March 19, 2019

Project No. 12091-01

**Subject: Preliminary Geotechnical Evaluation and Response to City Review Comments for Proposed San Pedro Distribution Center, 1599 W. John S. Gibson Boulevard, Los Angeles, California**

PROJECT NAME	San Pedro Distribution Center
PROJECT NO.	12091-01
ENG. / GEOL.	BTZ / KBC
SCALE	1" = 40'
DATE	March 2019

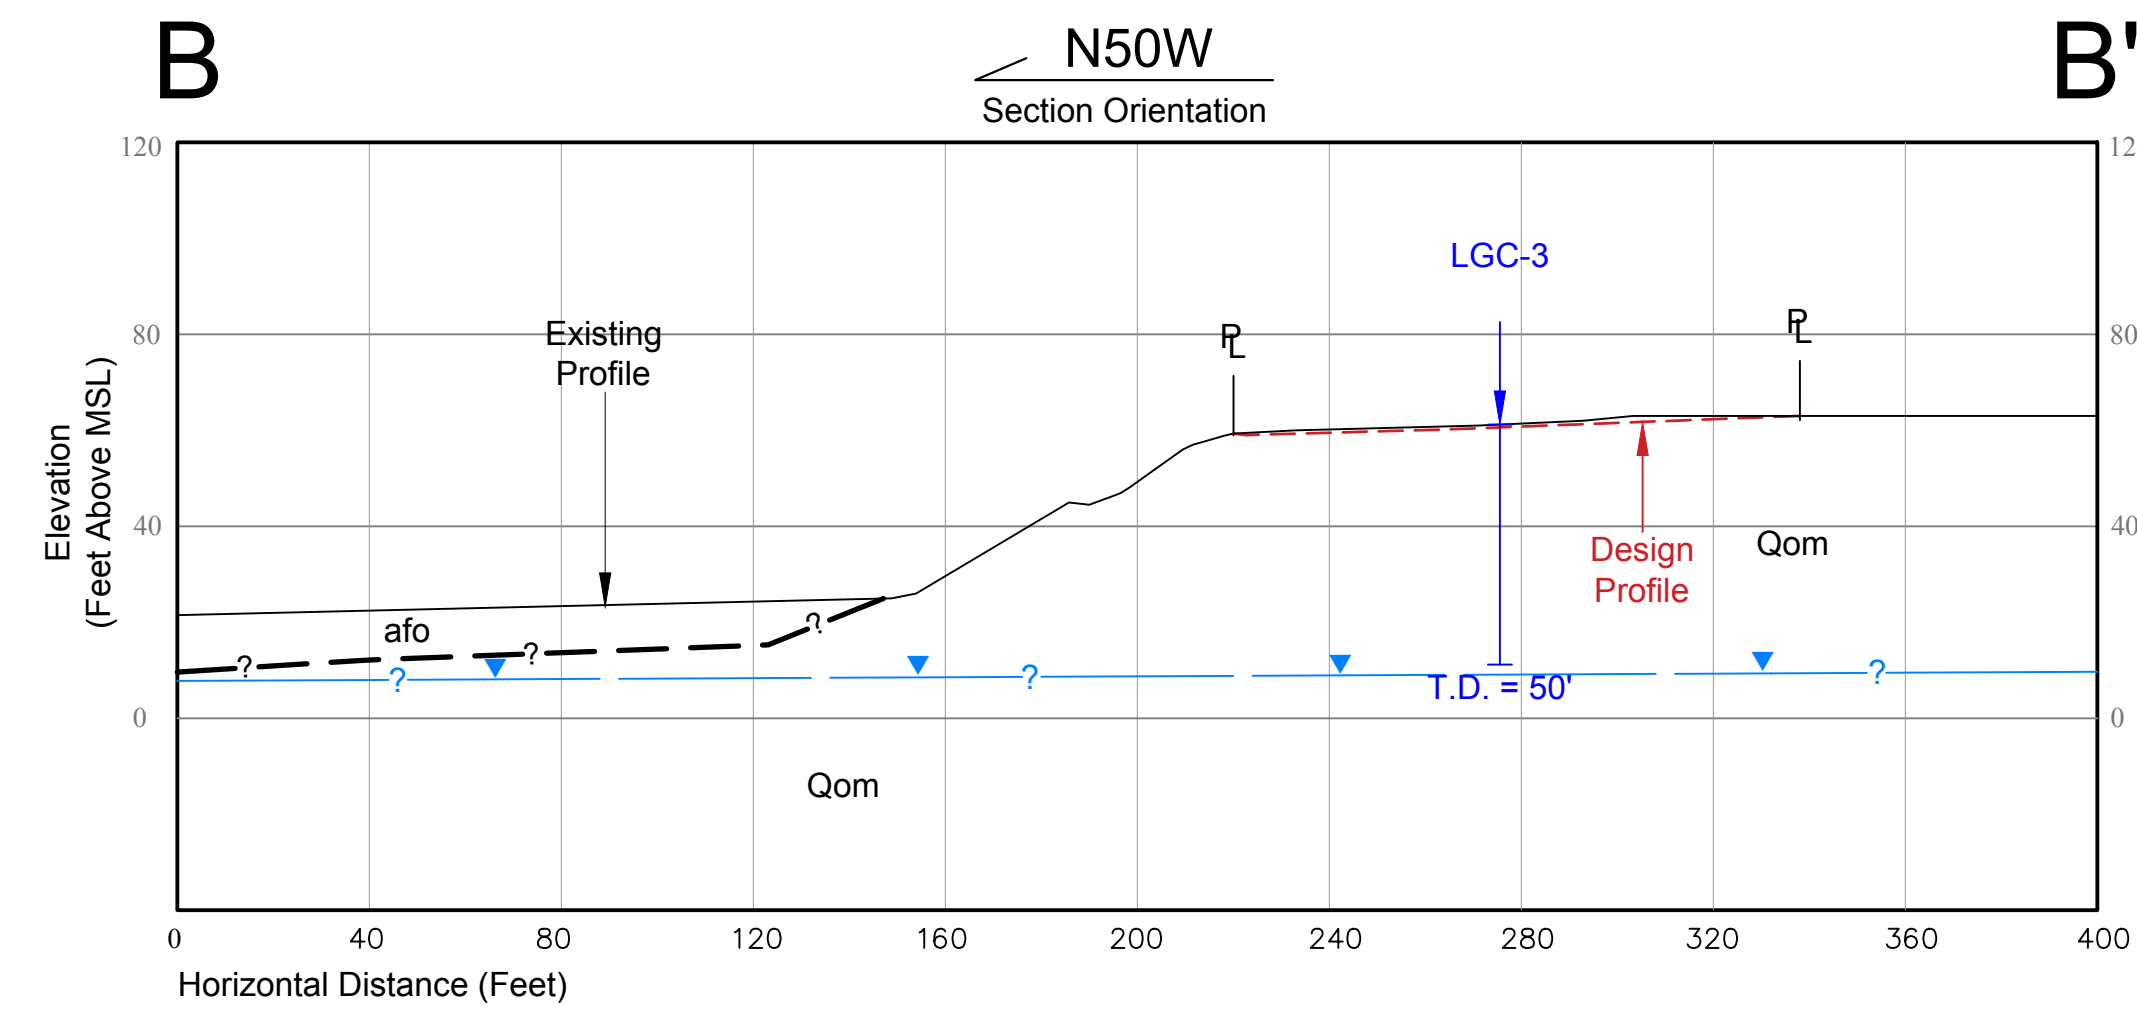
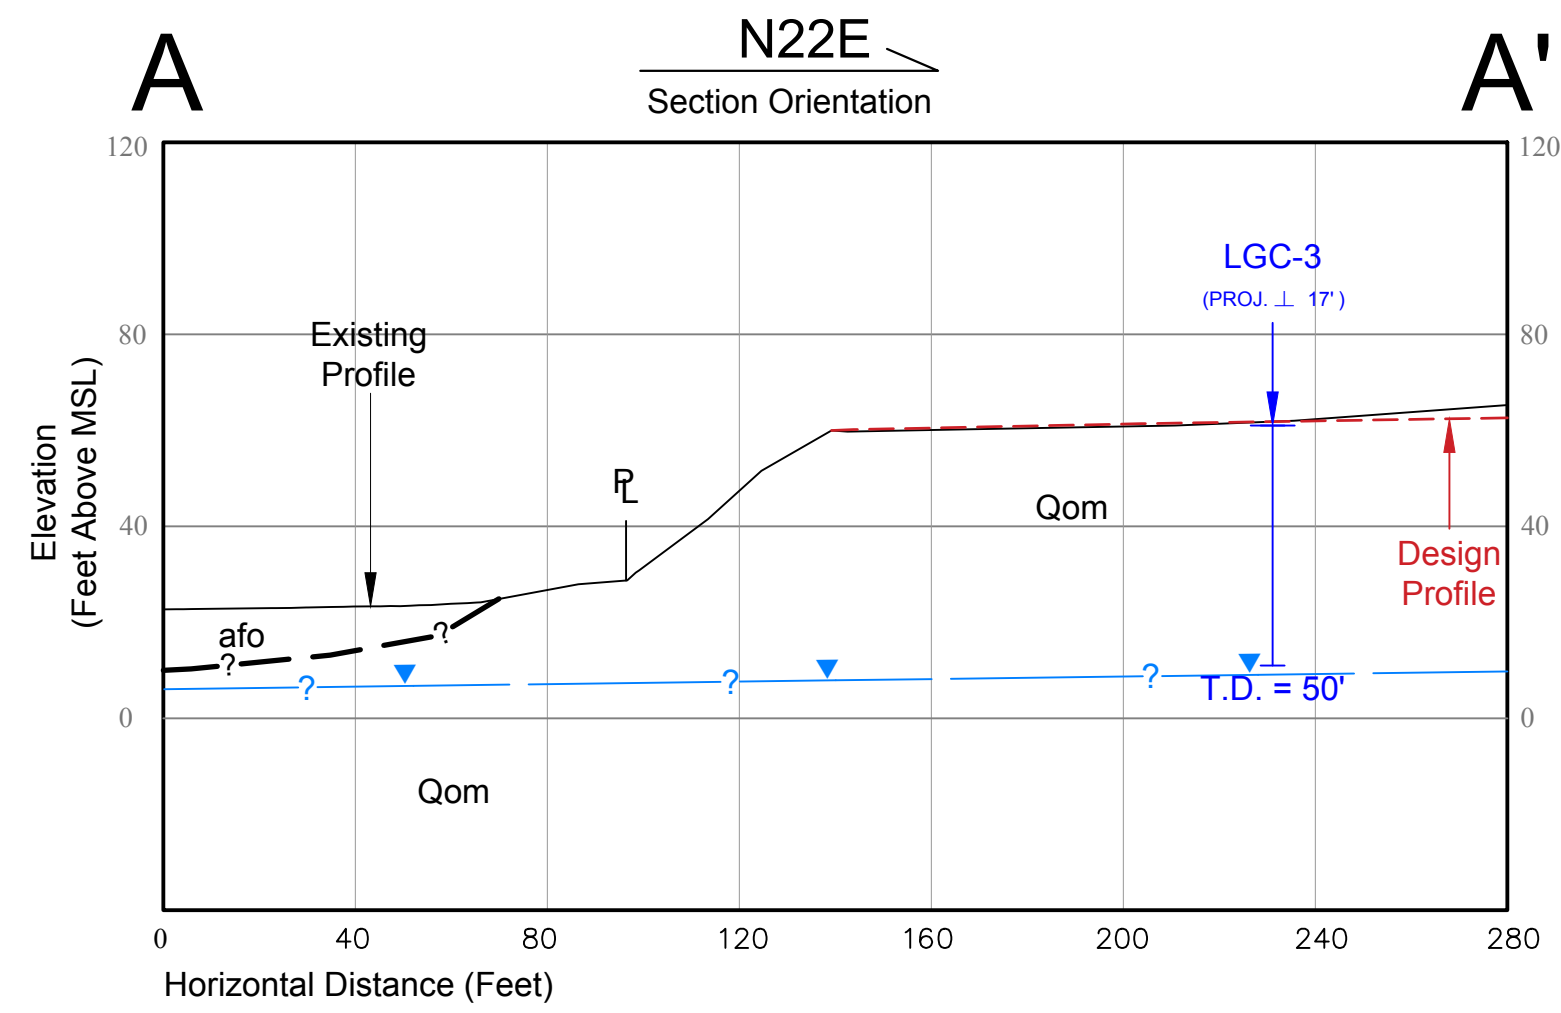
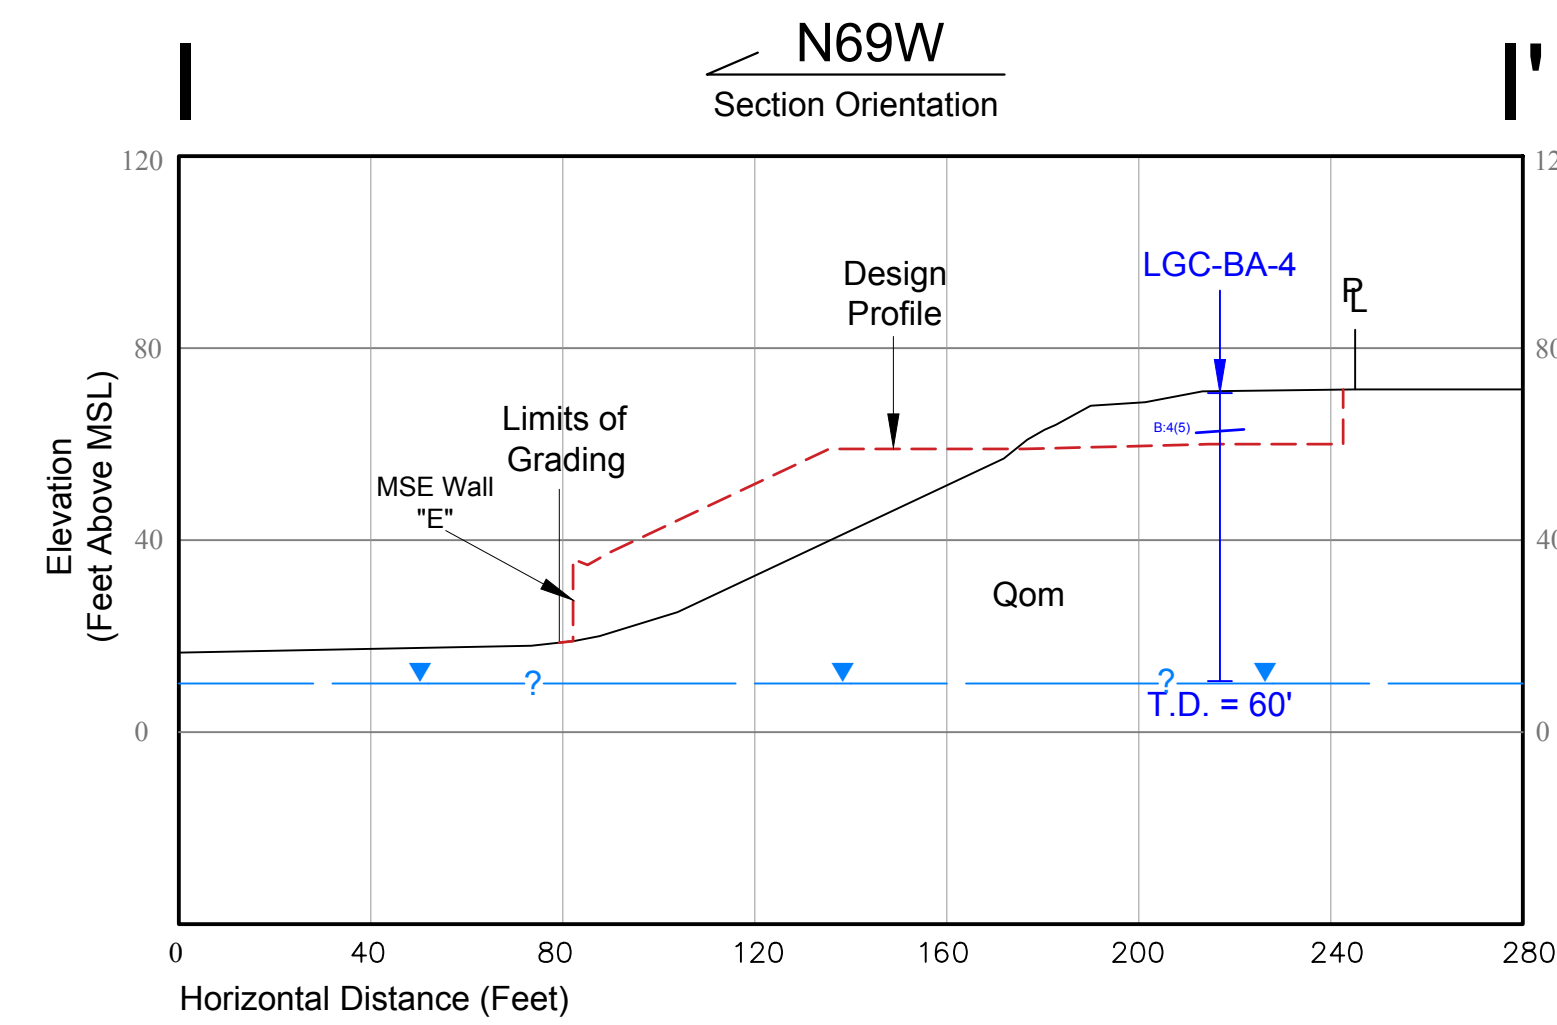
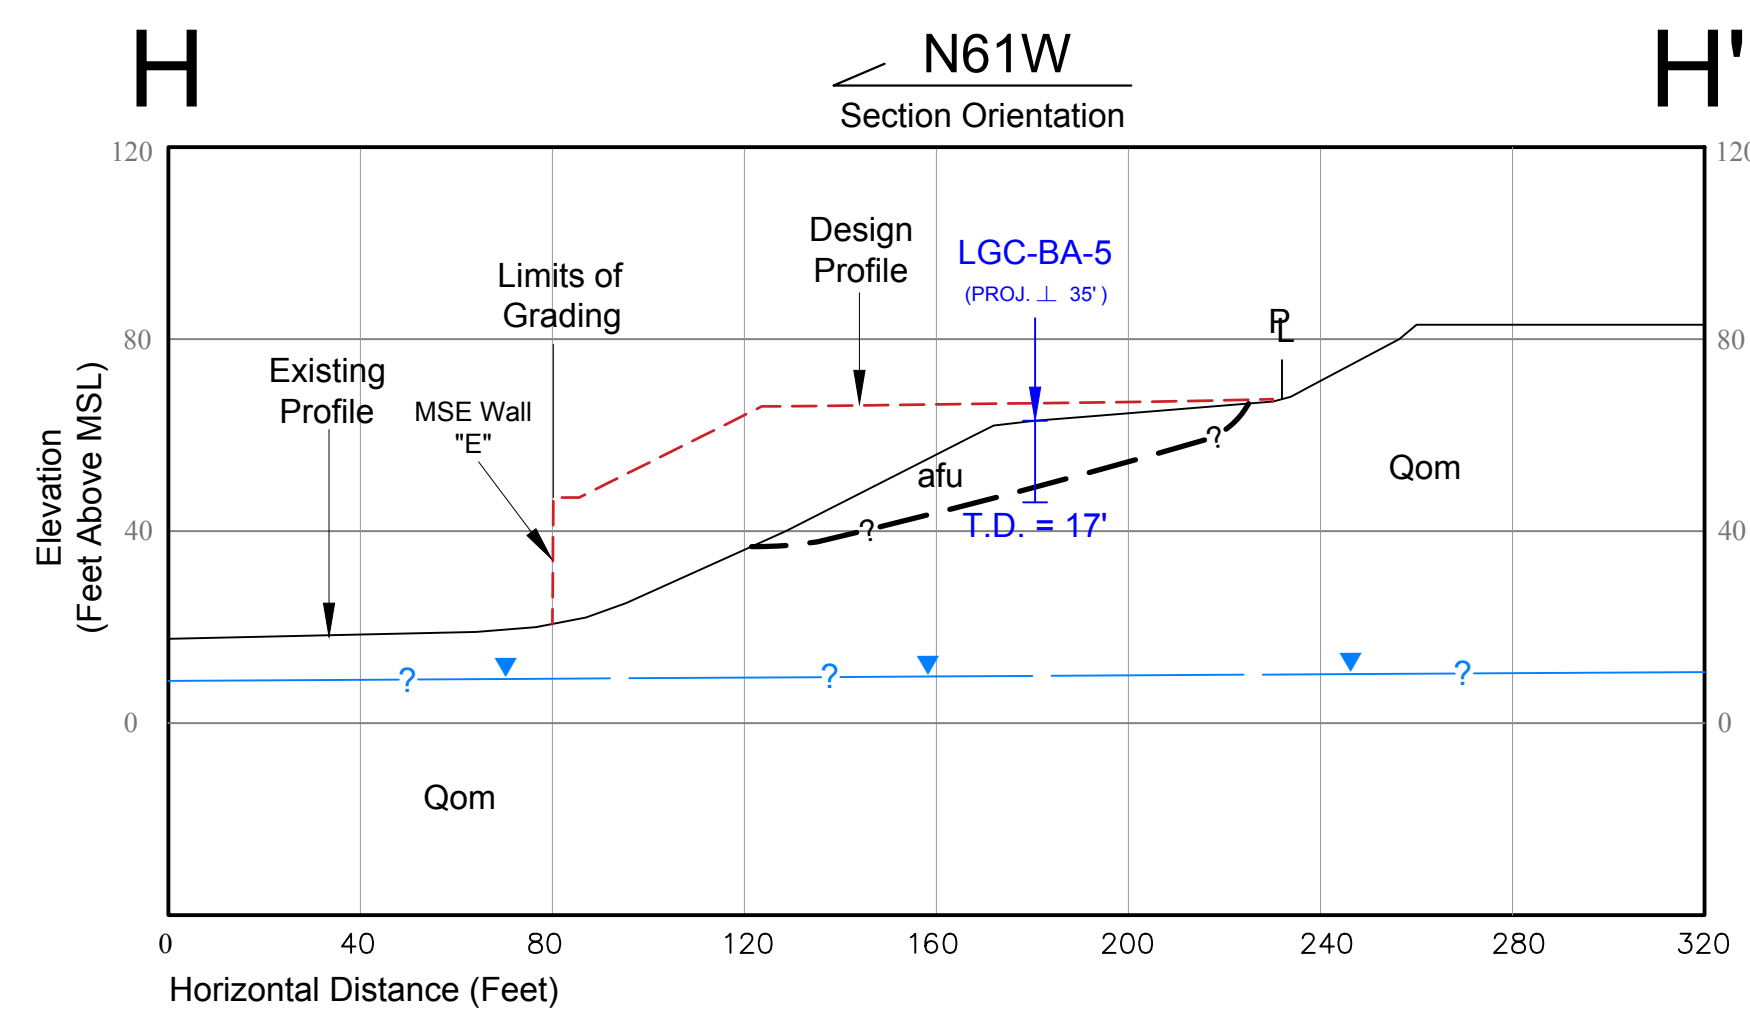
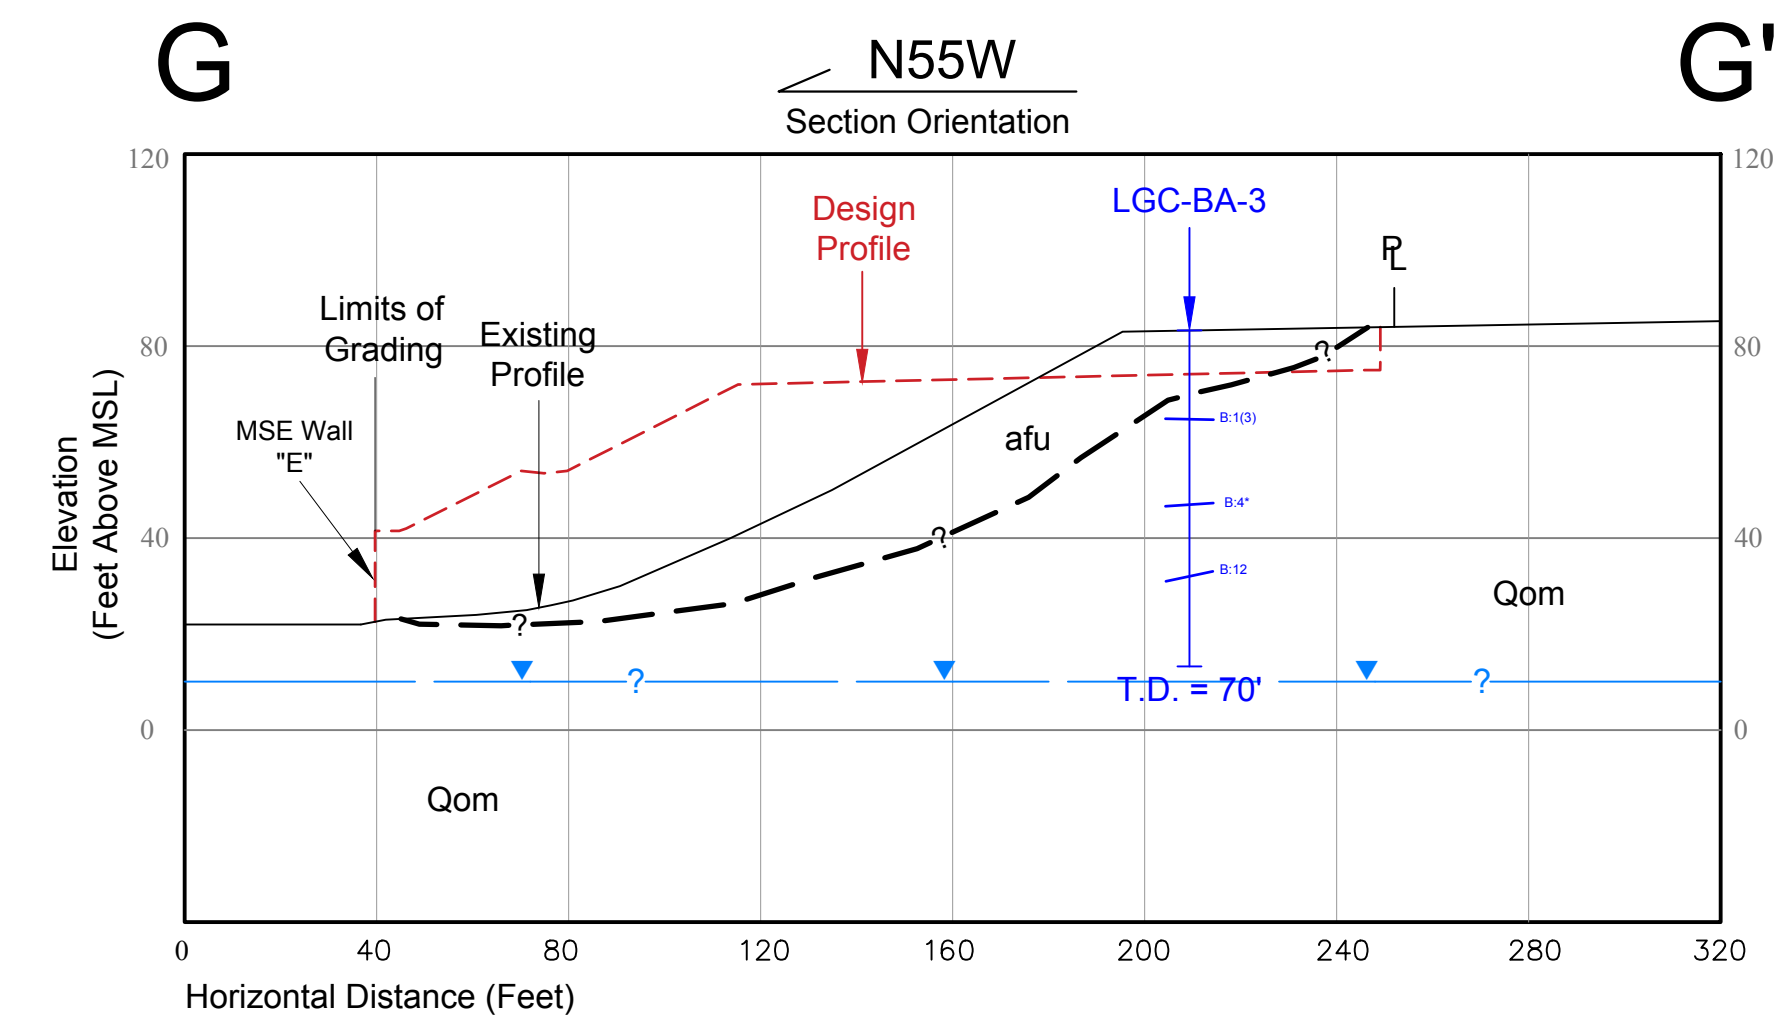
“Provide a geologic map and cross sections that are based upon conceptual grading or site development plans, to illustrate all proposed and existing contours relative to the planned grading and/or construction, along with all off-site slopes and conditions that could adversely affect the stability or safety of the site (7006.3.2). The geologic map and cross sections shall depict the top and bottom of slopes; lithologic contacts; bedding attitudes; locations of slumps, landslides, or faults relative to the subject site; existing and proposed topographic profiles; existing and proposed structures; and, required Code setbacks. (7006.3.2)”

“Provide geological cross sections illustrating existing and proposed grades and structures through the highest, steepest and geologically critical slopes.”

Refer to the attached Geotechnical Map and Geotechnical Cross Sections (Sheets 1 through 5). No building structures are planned for the site.
